## PETITION & LOCAL MEMBER OBJECTION

APPLICATION No. 18/02078/DCH DATE RECEIVED: 03/09/2018

LOCATION: 14 High Street, Llandaff, Cardiff, CF5 2DZ

PROPOSAL: ALTERATIONS TO PROVIDE HARD SURFACE, GATES AND REBUILD WALL PILLARS

A102

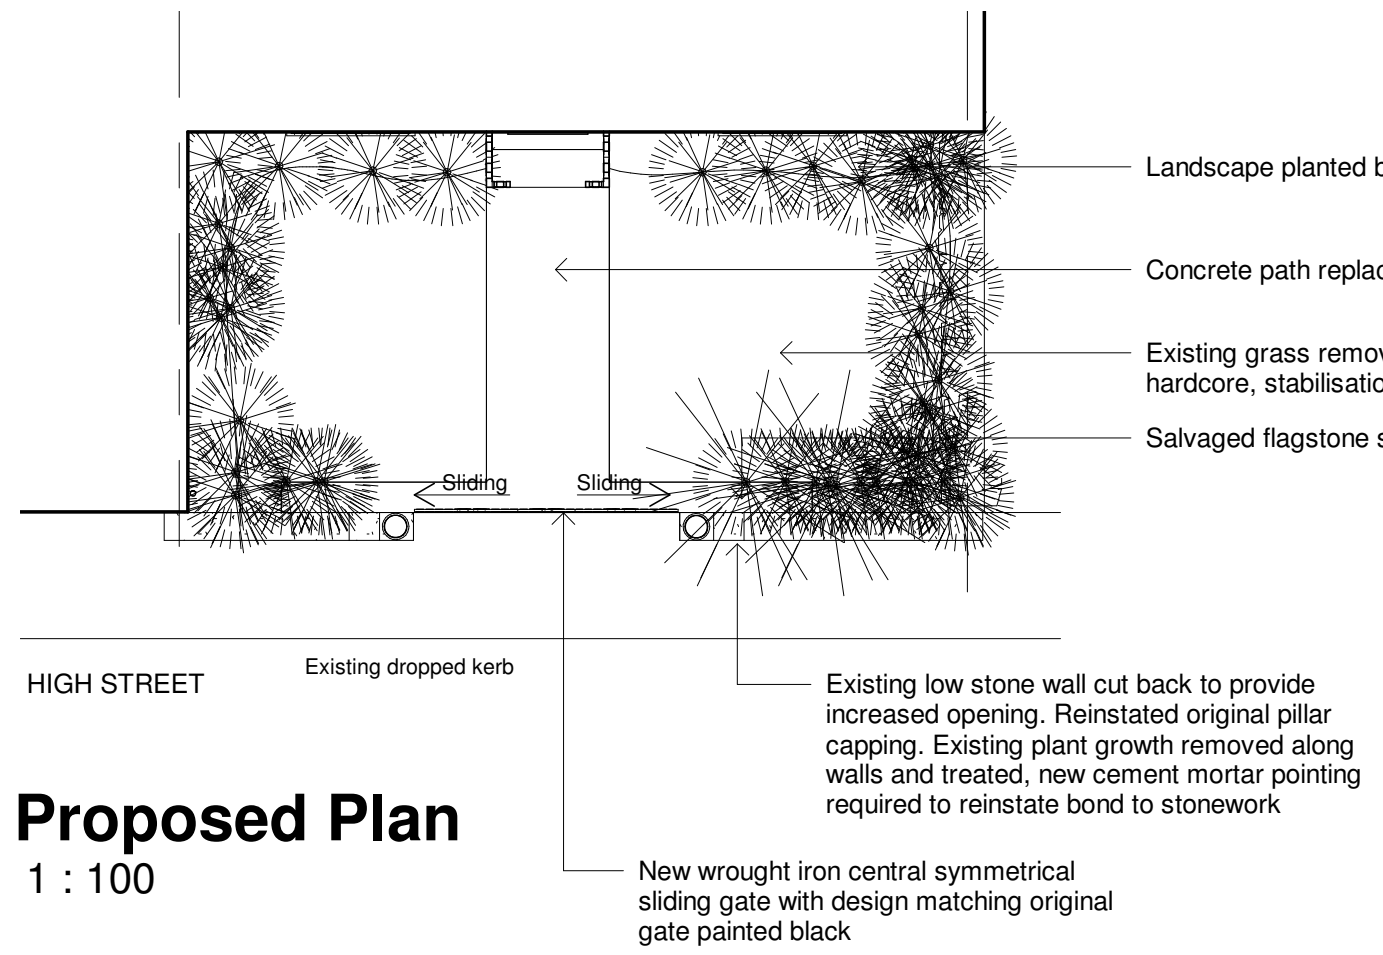
Measurement of the scaled drawings with the application suggests the distance between the edge of the porch to the footway is 4.2 metres which is less than the 4.8 required. The proposed planting, indicated to attempt to reduce the negative visual impact of the development, would also reduce the total space further. The document A104 - Proposed View submitted to support the application gives an entirely false impression of the size of the space and the way in which vehicles could be parked facing the building. This must be addressed with full and proper consideration.

*I would like to request that the council confirm that they have conducted a full and detailed assessment of the crossover and that the proposal meets all requirements, in terms of measurements, dimensions, (Measurement of the scaled drawings with the application suggests the distance between the edge of the porch to the footway is 4.2 metres which is less than the 4.8 required.) Also the Terms and Conditions for Crossovers as noted by the conservation group and noted again below:*

- 3 Prior to the commencement of the development hereby approved, and notwithstanding the approved drawing, details of the extent of the hard surface and its finish, which shall precisely confirm the areas of gravel, shall be submitted to and approved by the Local Planning Authority and the development shall thereafter accord with the approved details.  
Reason: To ensure the character of the Llandaff Conservation Area is preserved in accordance with Policy EN9 of the Local Development Plan.

b) Impact upon Highway Safety: It is considered the proposal would not have any adverse impact upon highway safety. The Council's Highways section have agreed the installation of the vehicular crossover, allowing vehicular access to the front curtilage with the property. The distance between the front elevation of the building and the front enclosure has been measured on site as 5 metres which confirms the scaled proposed plan drawing as

accurate. Whilst the distance from the porch to the footway is less than the minimum of 4.8m as recommended by the Highways section to ensure vehicles do not overhang the footway, in this particular instance it should be possible to park at an angle without the vehicle overhanging the footway.
